# **Proposed Redevelopment of the Marrickville Metro Shopping Centre**

## **Review of Traffic Management and & Accessibility Plan**

Prepared by  
**Fred Gennaoui**

**For Department of Planning &  
Infrastructure**

# PRINCIPAL ARRIVAL/DEPARTURE DISTRIBUTION

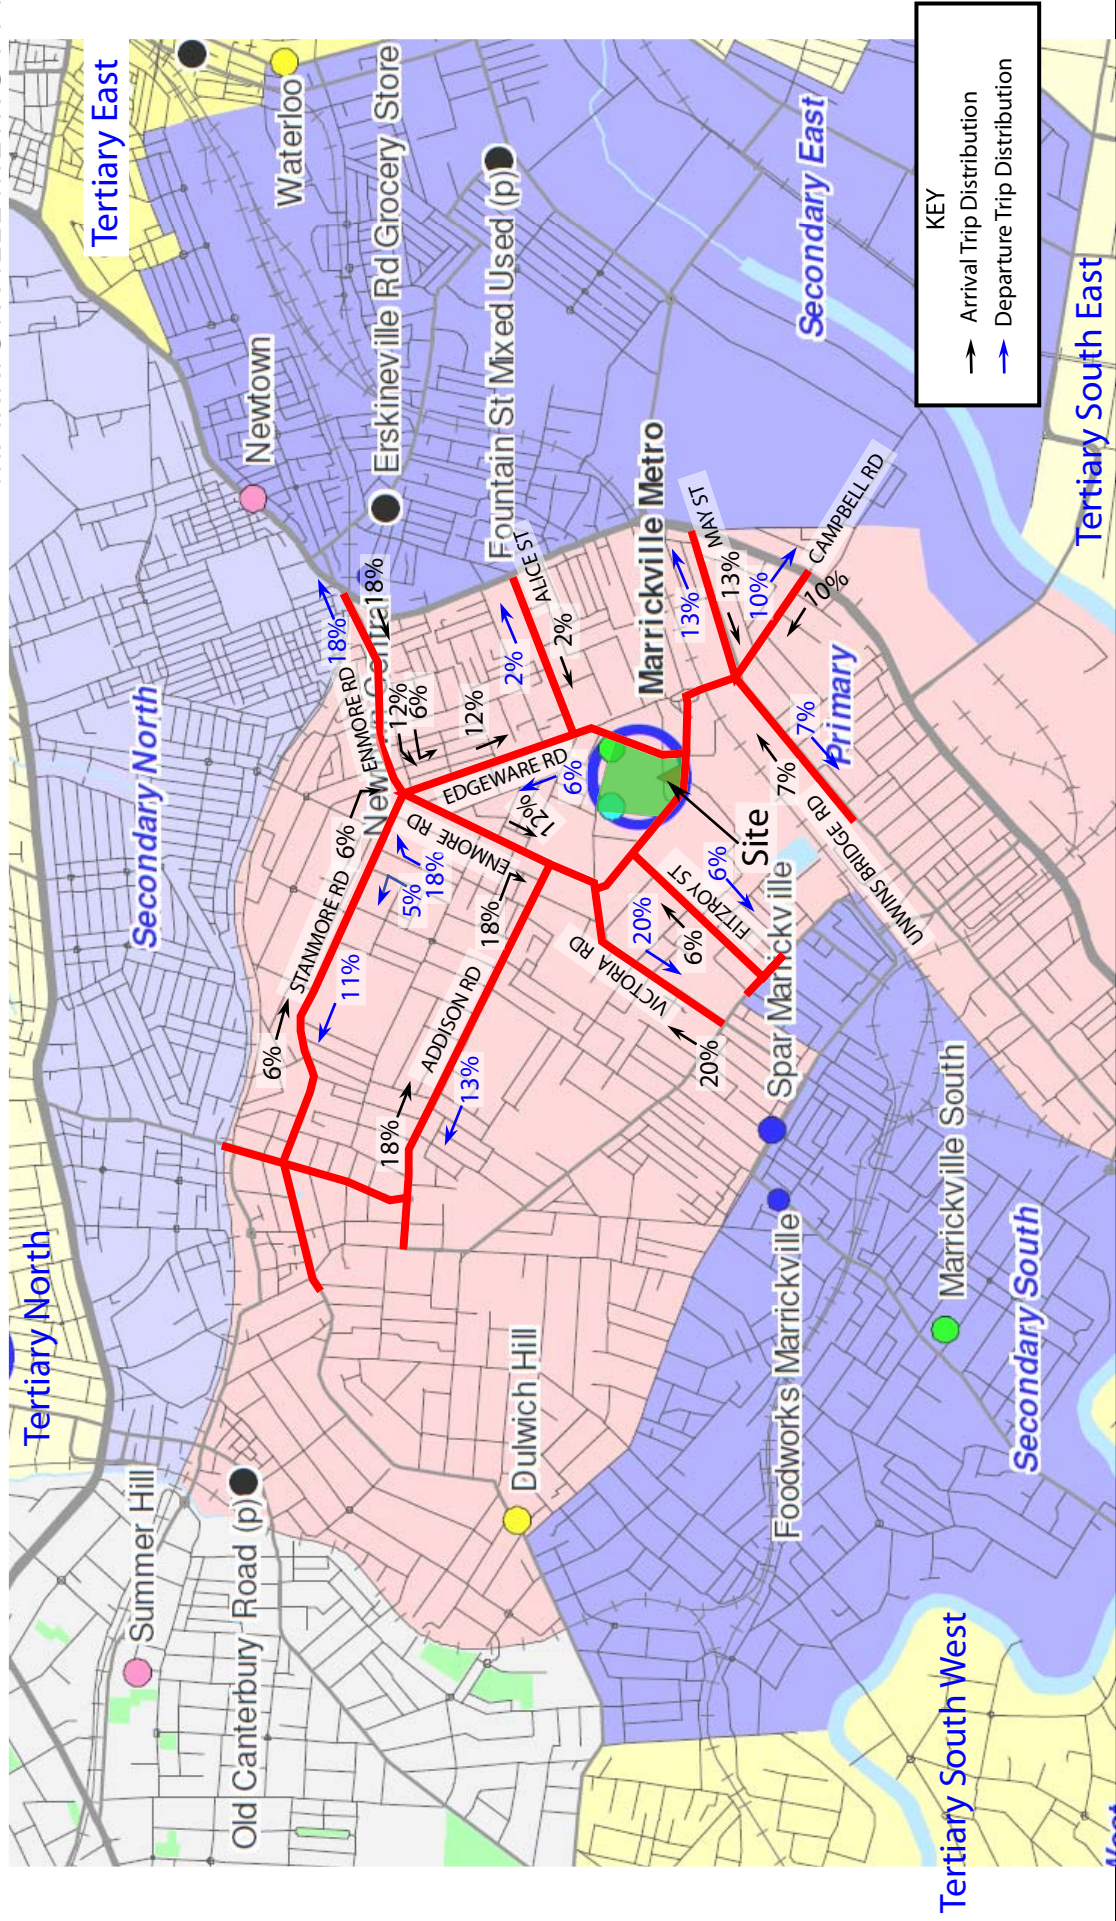
In response to a query from Gennaoui Consulting, Halcrow has provided an explanation on the methodology adopted for the derivation of the distribution of the additional shopping centre trips generated. This explanation is also included in **Appendix B**. The majority of additional shopping centre traffic was assumed to use the car parking area to the south of Smidmore Street. This is consistent with the fact that most additional parking spaces will be provided on the southern site.

This explanation is considered reasonable explanation in relation to lesser traffic using Edgeware Road.

# LANE RELOCATION AND PARKING RESTRICTIONS FOR UNWINS BRIDGE ROAD AND MAY STREET

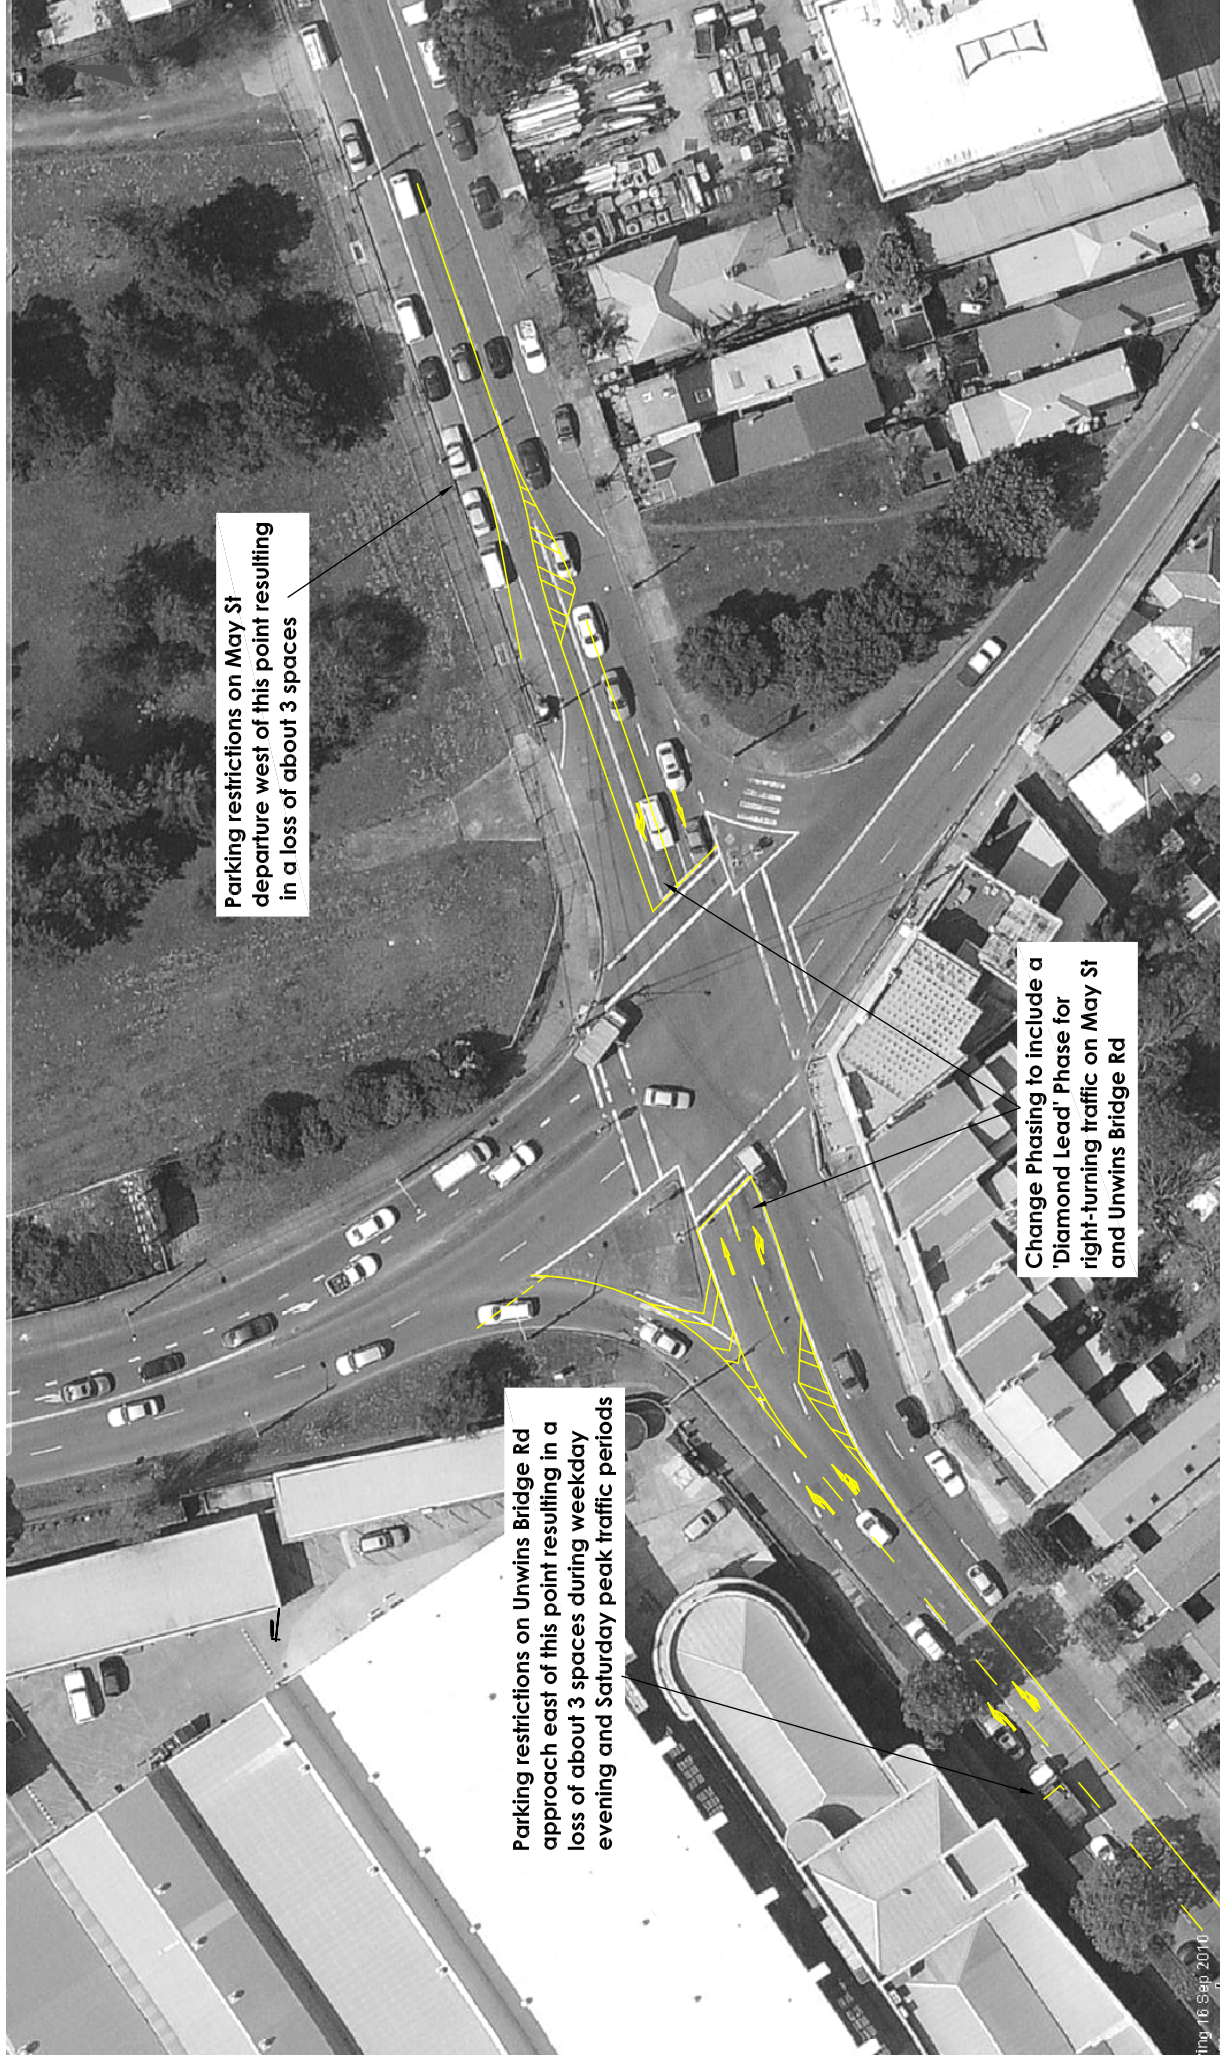
- < Create a dedicated left slip lane of about 60m by implementing parking restrictions (clearway or permanent) on the Unwins Bridge Road approach;
- < On May Street convert the existing right and through lane to a dedicated right-turn lane. Add a right-turn phase for vehicles turning from May Street into Bedwin Road; reducing the eastbound provision in May Street to one lane and displacing about three parking spaces
- < introduction of a 'diamond lead' phase for right-turning traffic on approaches east west approaches

The above proposed improvements are shown in **Appendix F**. These measures considerably improve the operation of this intersection. The RTA has given approval in principle for the proposed modification subject to a number of further modifications. The final design and operation of the intersection should be agreed in consultation with the RTA and Council

Proposed Pedestrian Routes  
Improvements

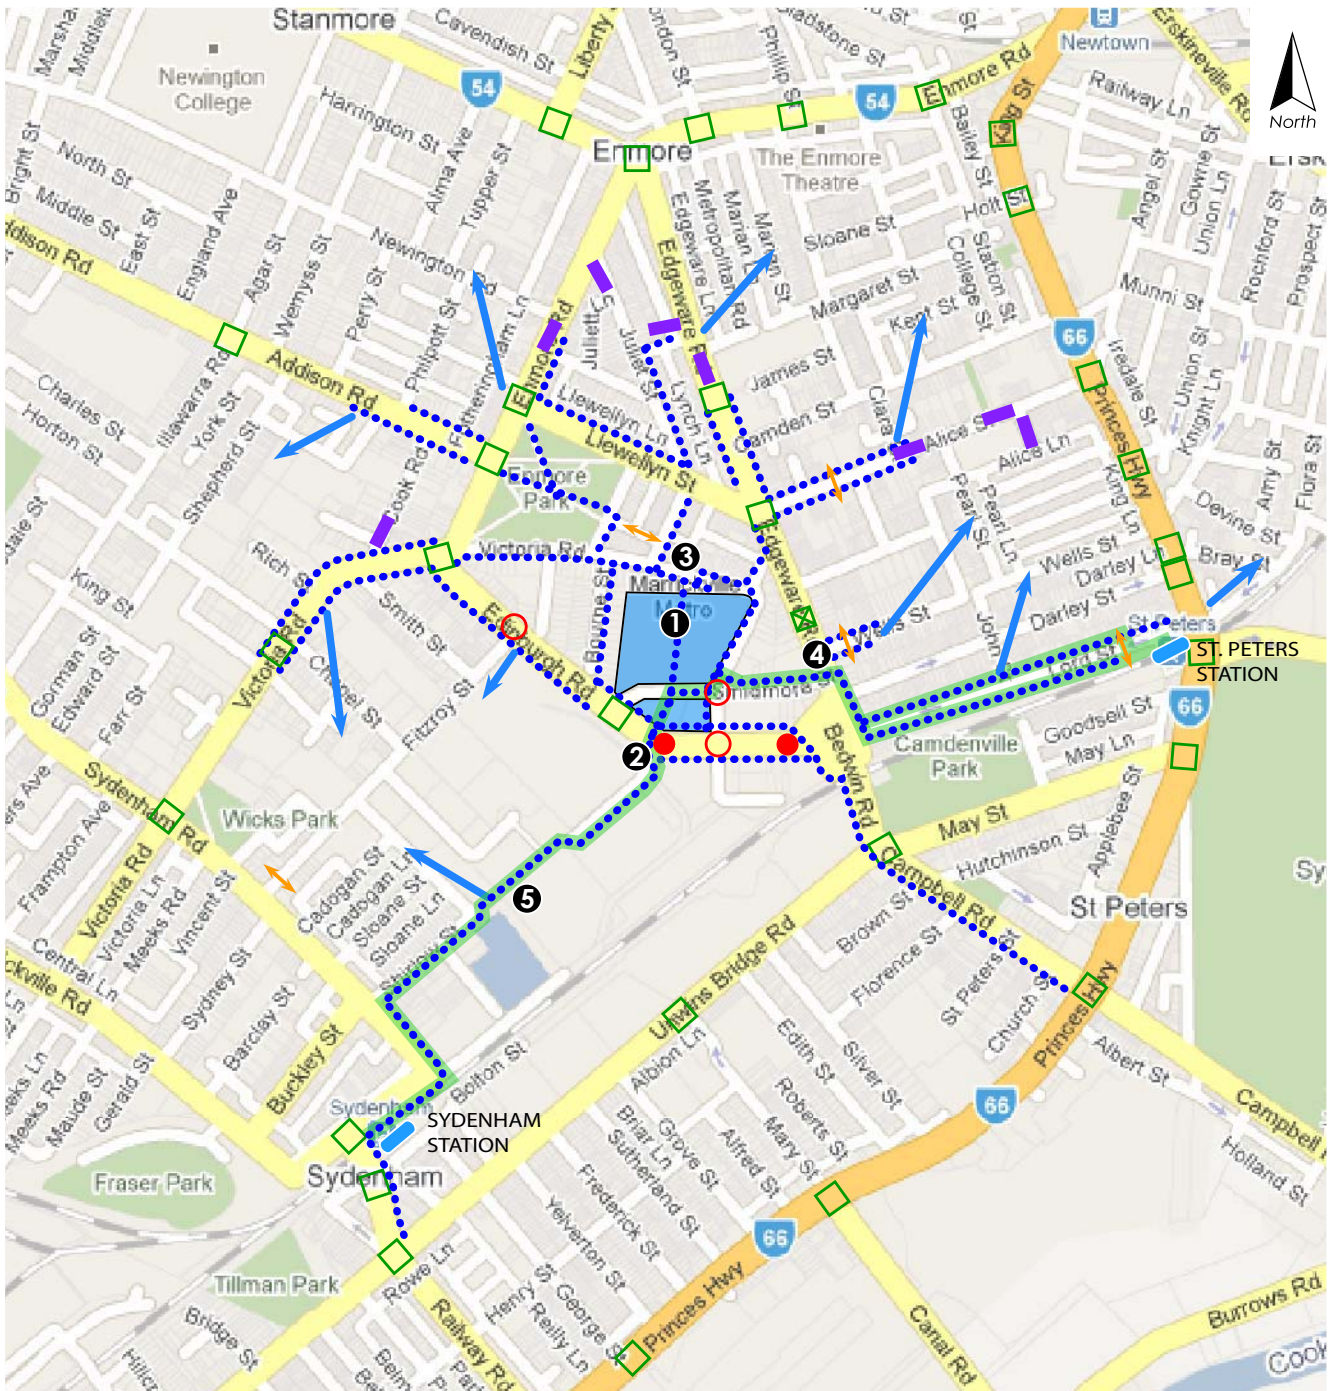
The proposed development incorporates a number of improvements for pedestrians as indicated on the Figure 10 in **Appendix H**. These measures include

The improvements identified in section 2.5.1, shown in **Appendix H** and travel information display proposals, which will show pedestrian routes to the stations, as discussed in the Section 10, *Green Travel Plan*, of the July report (Halcrow, 2010a) would enhance accessibility to and from the two railway stations.

### Proposed Bicycle Improvements

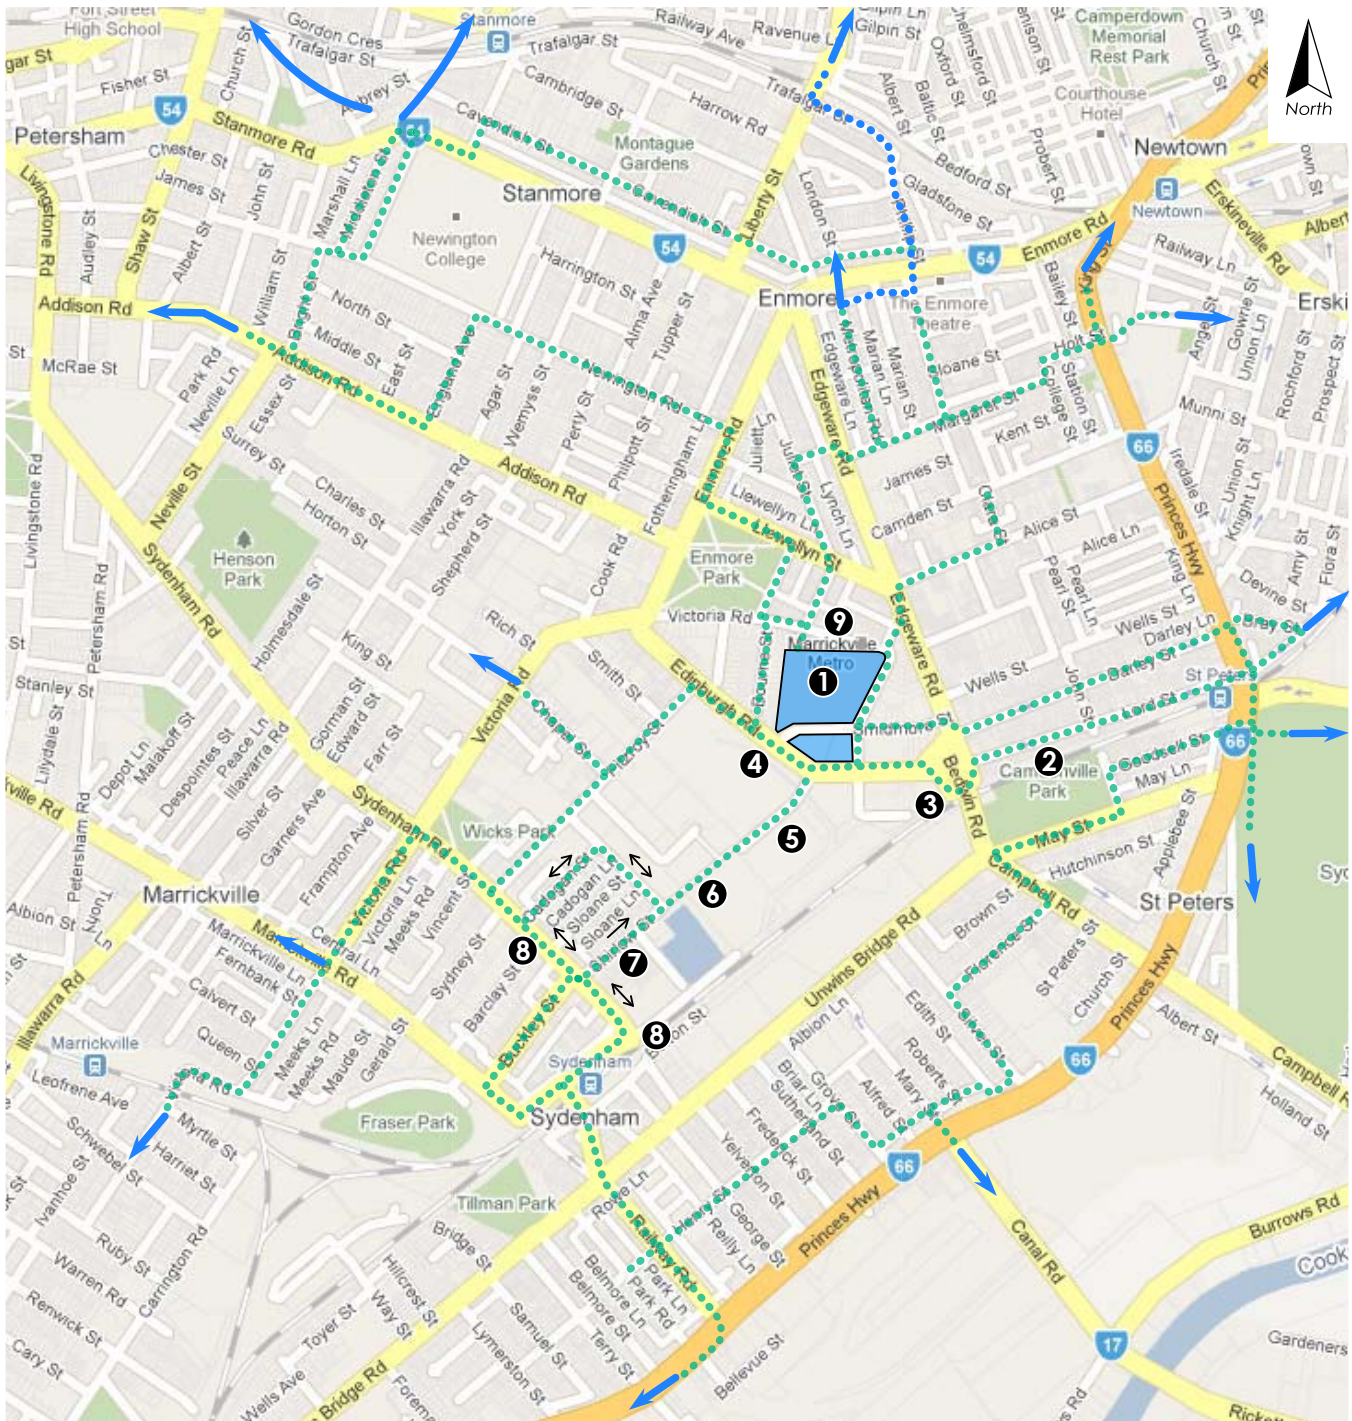
A number of bicycle routes access the Marrickville Metro shopping centre are shown on Figure 7 of the July report (Halcrow, 2010a). Halcrow (2010a) have proposed a number of improvements to the cycle network as illustrated in **Appendix I**. The proposals are supported and should form part of the approved TMAP. It is noted that approval from Marrickville Council would be required.
